MEMORANDUM

To: Development Review Board
From: Mary O'Neil & Scott Gustin
Date: July 19, 2011
RE: ZP 11-1065CA/CU; 26 Summit Street

1. Conditional Use review for addition of another unit within the RL zone: Change front building from single family to duplex. Existing duplex at rear for a total of four units on the property.
2. Conditional Use review for waiver request from Functional Family provision of the Comprehensive Development Ordinance.
3. Expanded parking.

SHEET TITLE:
NEW SITE PLAN

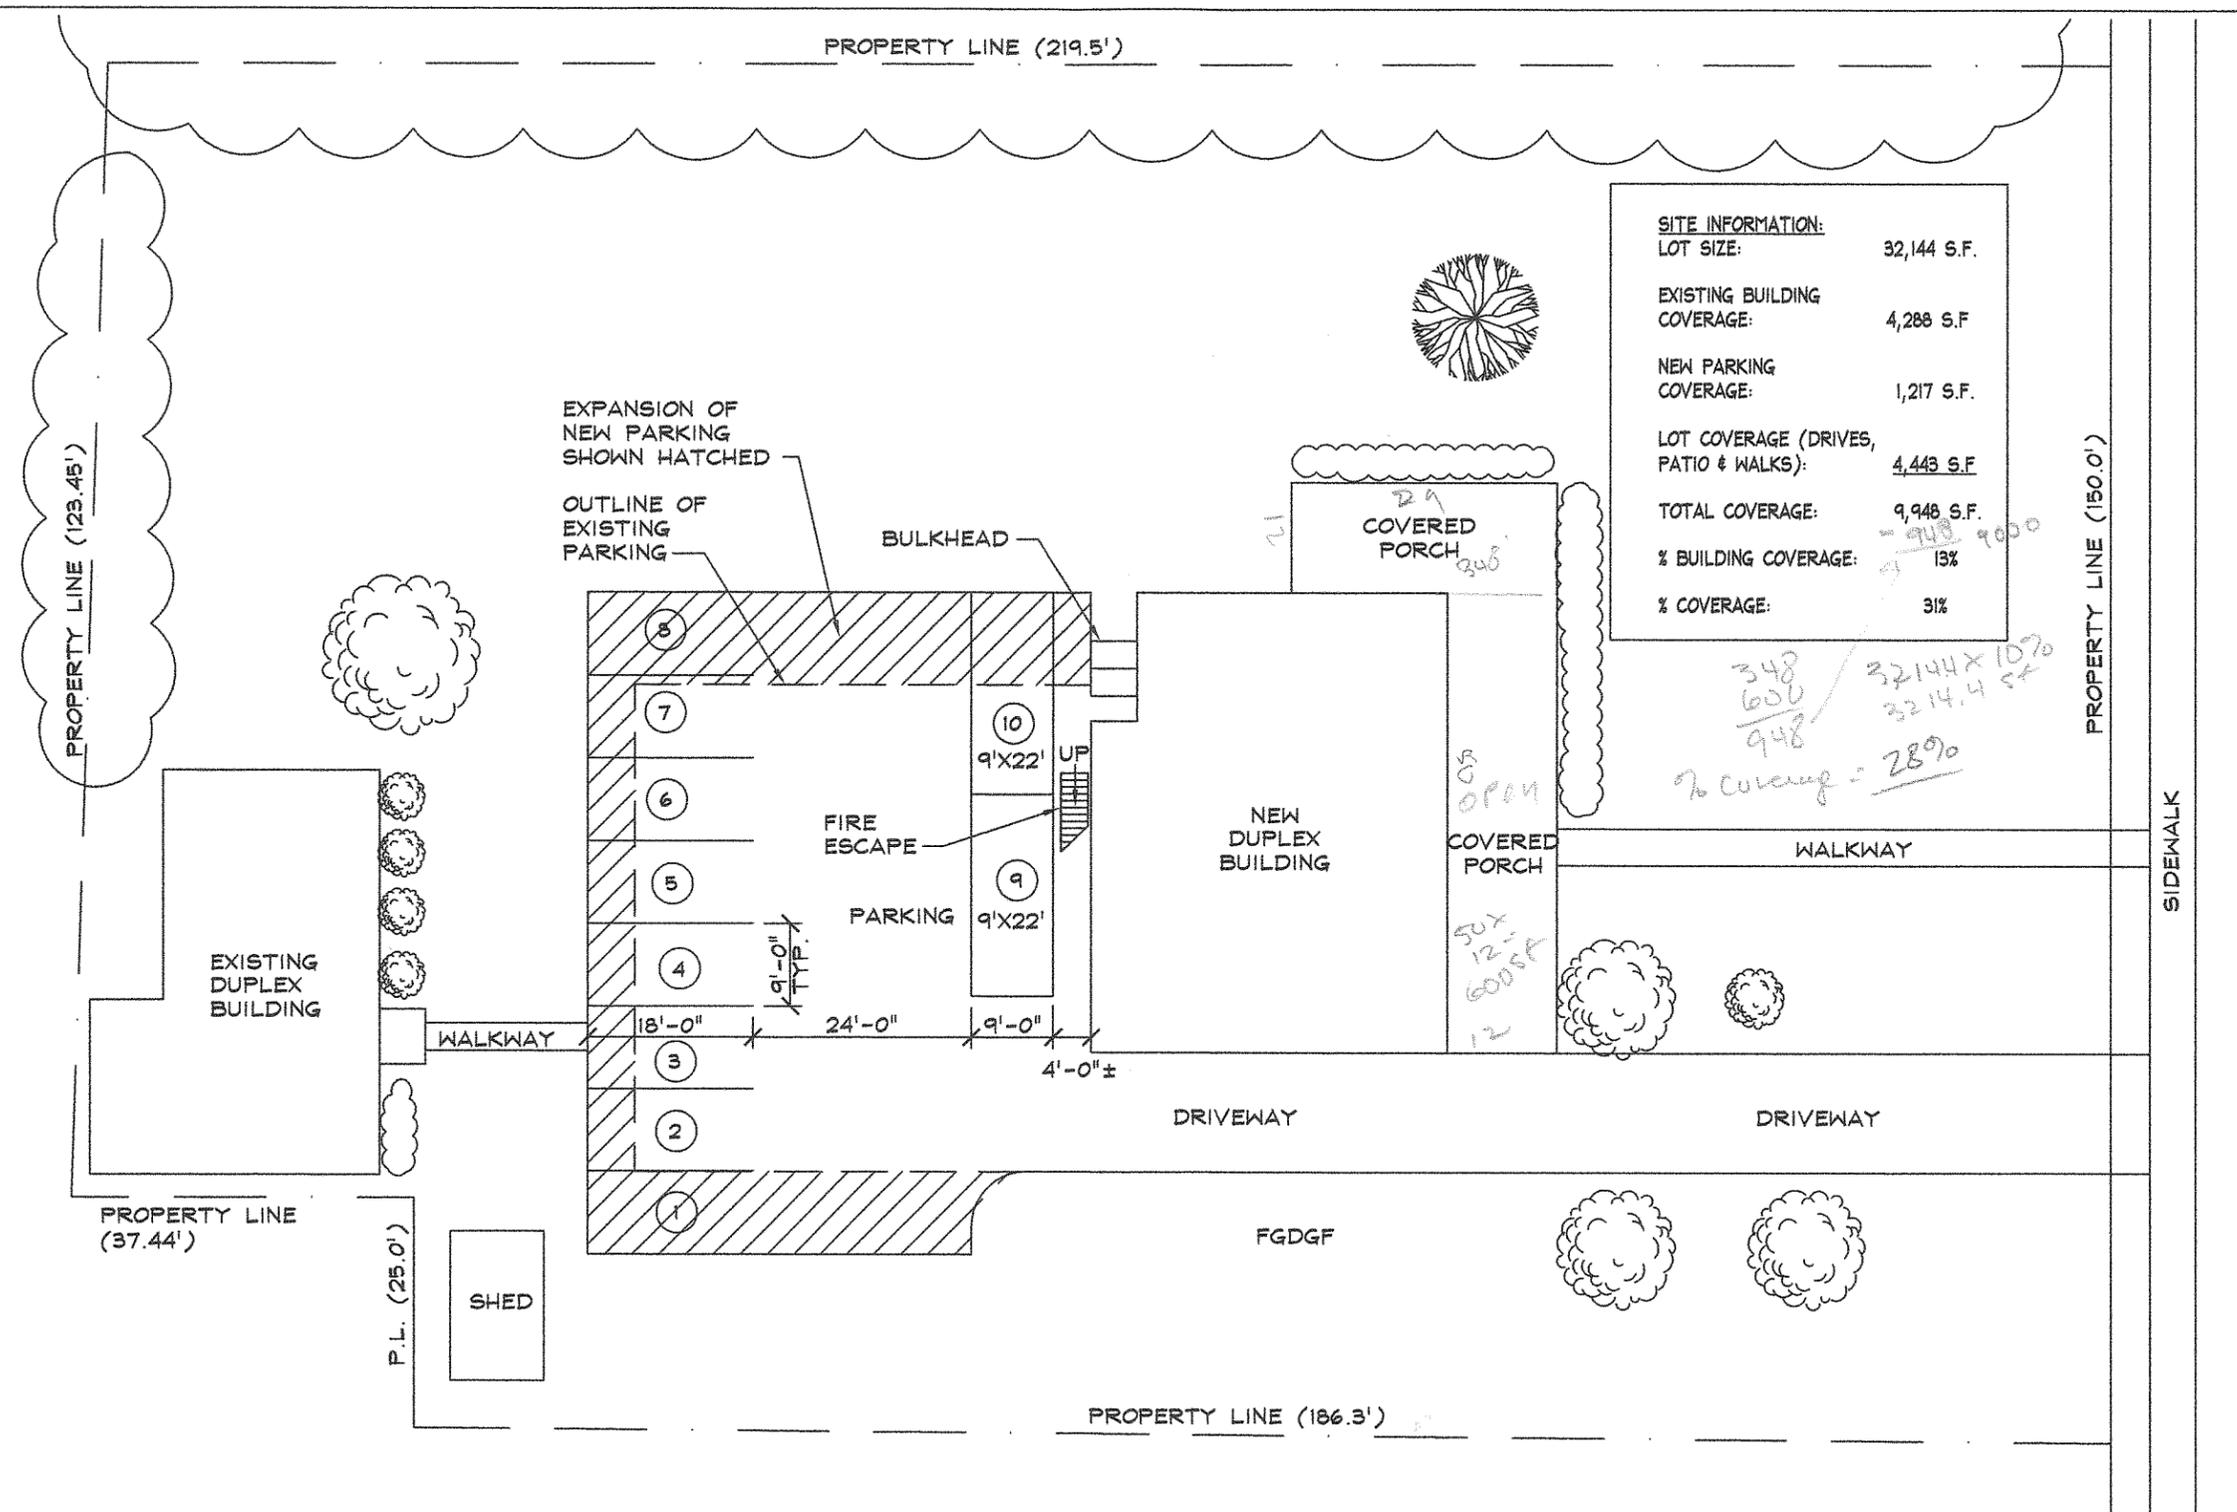
The application is requesting tenancy in excess of the four unrelated adults provision, and thus has provided two additional parking spaces on site, measuring 9' x 22'. While this satisfies the 180 sq. feet for 2 parking spaces, there are two problems. The other 8 parking spaces are compact. While the explicit limitation of compact parking spaces to 15% of the total pertains to parking garages (Sec. 8.1.12 {h}), it is inadvisable to exceed the limitation in surface parking applications as well. There is sufficient space to further expand the parking area to provide full size spaces. Note that the provision of 2 additional parking spaces assumes that only 2 more unrelated adults will be living in the unit. As these are spacious bedrooms, it is conceivable that more than 6 adults will inhabit this fourth unit, and thus additional parking may be needed once the number of occupants is determined. **No finding possible.**

The proposed parking configuration has the potential for headlight glare immediately into the rear duplex, as well as into properties both north and south of the parcel due to parking spaces #9 and 10. Appropriate landscaping and parking barriers are recommended to mitigate this impact. **Affirmative finding if conditioned.**

Coverage is limited to 35% in the RL zone, exclusive of bonus provisions (decks, patios, open porches.) The proposed plan for expanded parking would increase coverage by 1,217 sq. ft. for a total coverage calculation of 31%; however, taking into account the large open porch the base lot coverage is reduced to 28%, well below the maximum allowed. **Affirmative finding.**

The standard size for a parking space at a 90° angle is 9’ x 20’. The submitted site plan details 8 parking spaces 18’ long, which is a compact car space. While this provides the necessary 24’ backup space required by the ordinance, it does not provide adequately sized parking spaces. As noted there is sufficient space and lot coverage to allow an increase in parking and expansion of the size of the spaces. **No finding possible.**

2. **Prior to release of the zoning permit**, appropriate landscape screening of headlights, and parking barriers shall be installed and illustrated on a revised site plan. Such plan shall be reviewed and approved by staff.

5. Compact Car parking spaces should be limited to 2 (15% maximum of 10 spaces.) All other spaces, except any parallel spaces, shall be minimally 9' x 20', and have sufficient back-up space per Table 8.1.11-1 of the CDO. **Prior to release of the zoning permit**, a revised site plan shall be submitted illustrating these revisions to the parking plan, with measurements provided.

SHEET TITLE:
NEW SECOND & THIRD FLOOR PLANS

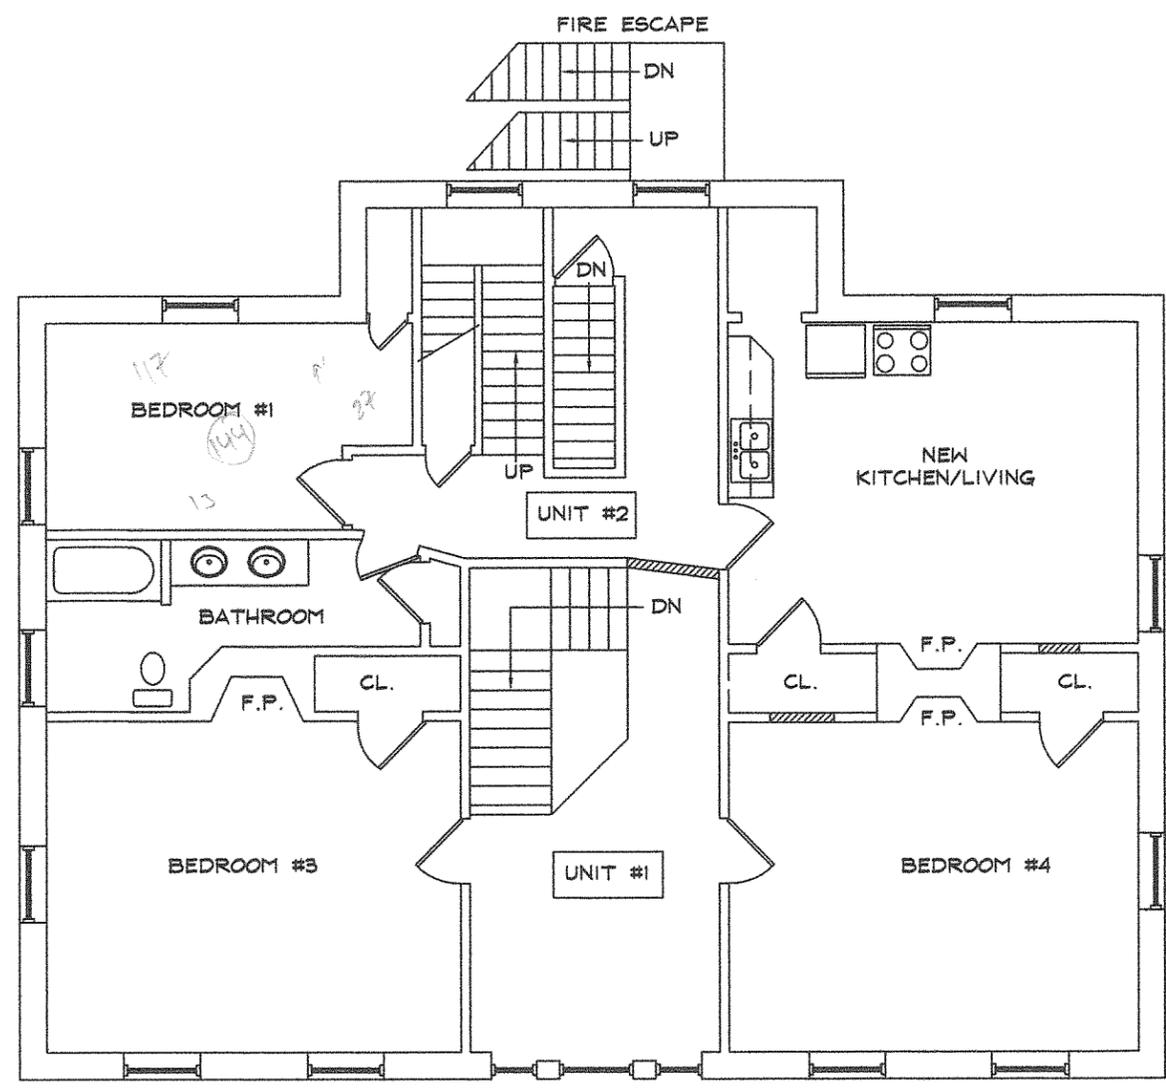
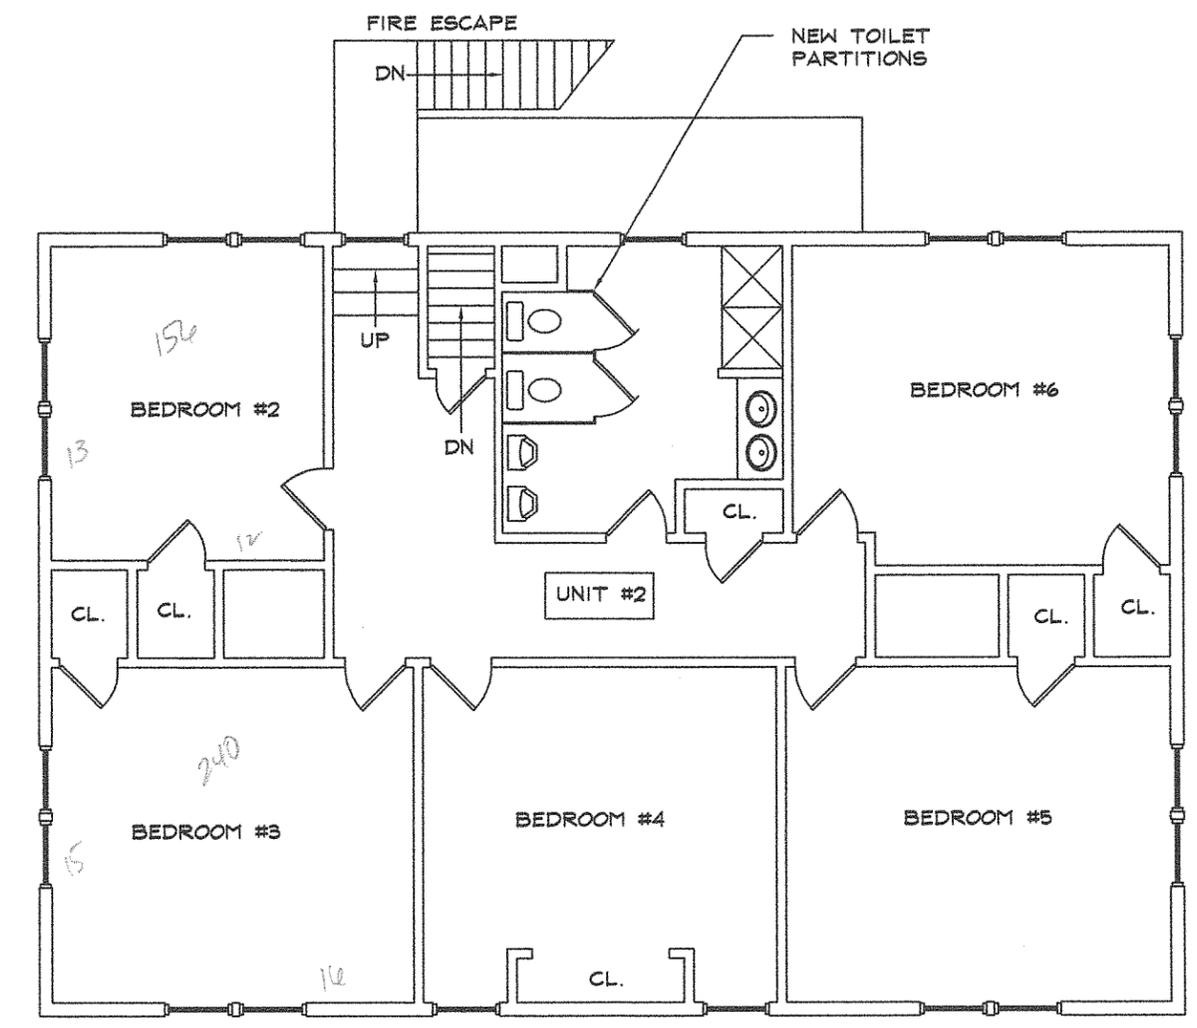
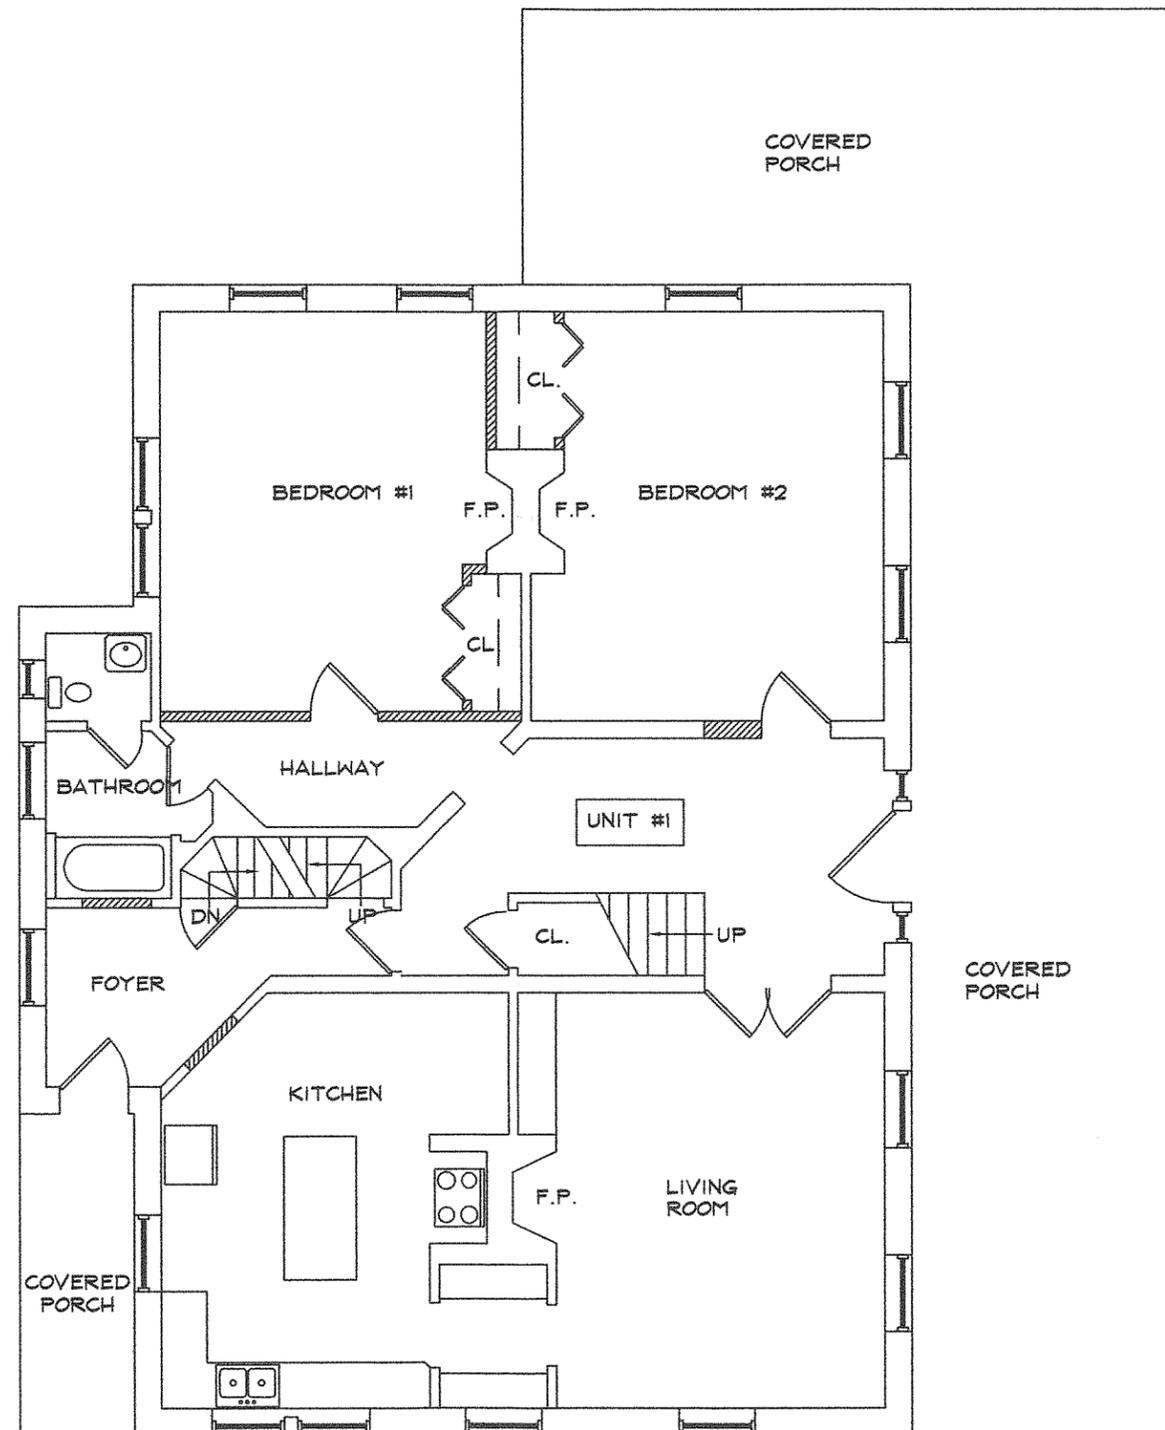
Submitted floor plans show free movement to bathrooms and kitchen facilities without passing through any proposed bedroom. The kitchen and living room, however, are combined; a seemingly crowded configuration for a six bedroom apartment. **Affirmative finding.**
